Economic Commission for Europe**Inland Transport Committee****World Forum for Harmonization of Vehicle Regulations****Working Party on Lighting and Light-Signalling****Sixty-fourth session**

Collective amendments – Regulations Nos. 6, 7 and 48**Proposal for Supplement 19 to the 02 series of amendments to Regulation No. 7 (Front and rear position lamps, stop lamps and end-outline marker lamps)****Submitted by the experts from the Working Party “Brussels 1952”***

.....
Rear position lamps

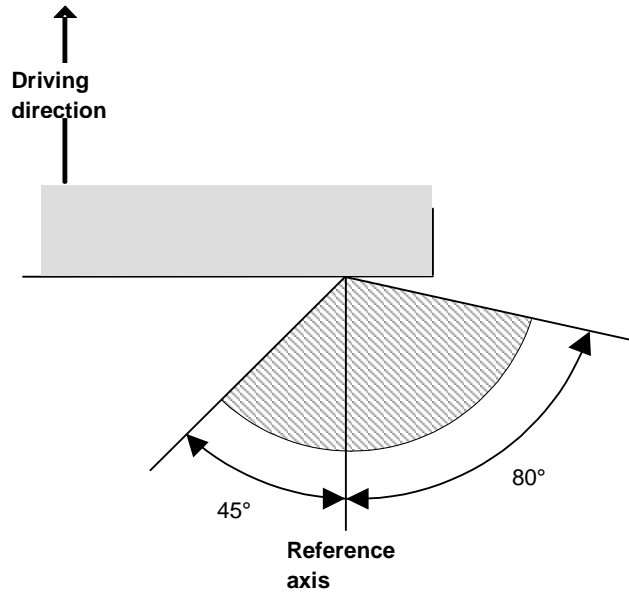
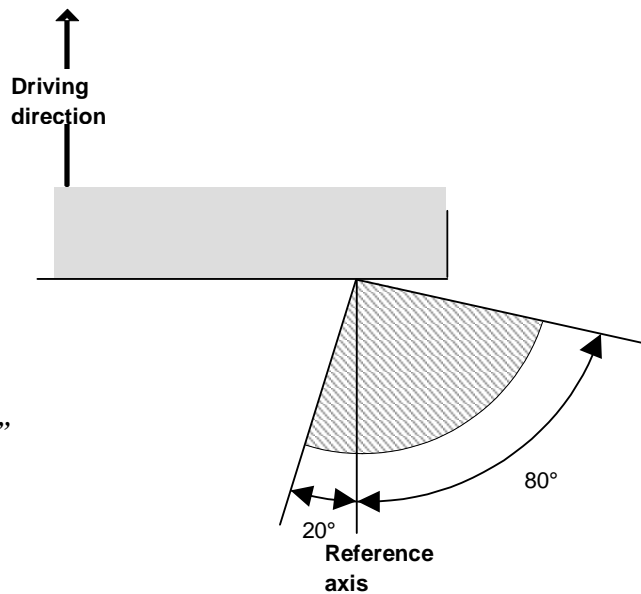
On and above the H plane for all lamps.

Under the H plane for rear position lamps intended for M₂, M₃ or N₂ category of vehicles or end-outline marker lamps for all categories of vehicles

Under the H plane only for rear position lamps intended for M₁ and N₁ category of vehicles, and being installed at a mounting height less than 750mm above ground.

Stop-lamps (S1 and S2)

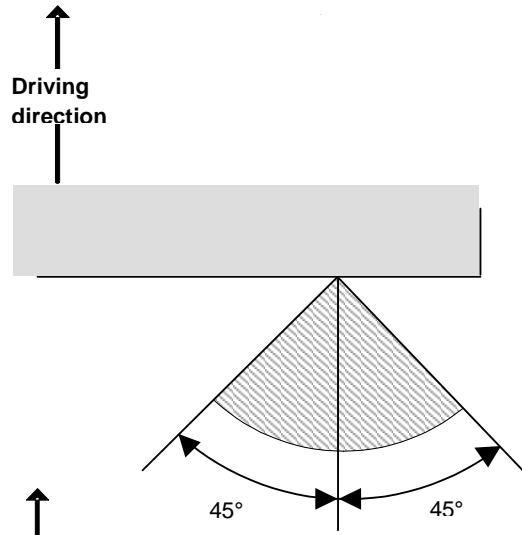
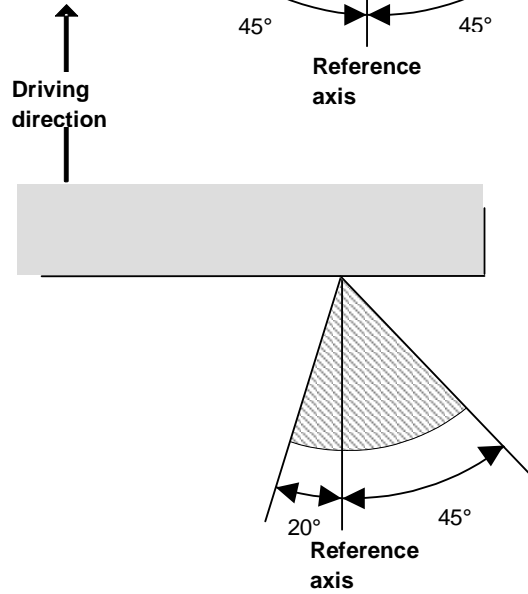
*On and above the H plane for all lamps.
Under the H plane for lamps intended for M₂, M₃ or N₂ category of vehicles*

Under the H plane for lamps intended for M₁ and N₁ category of vehicles, and being installed at a mounting height less than 750mm above ground.
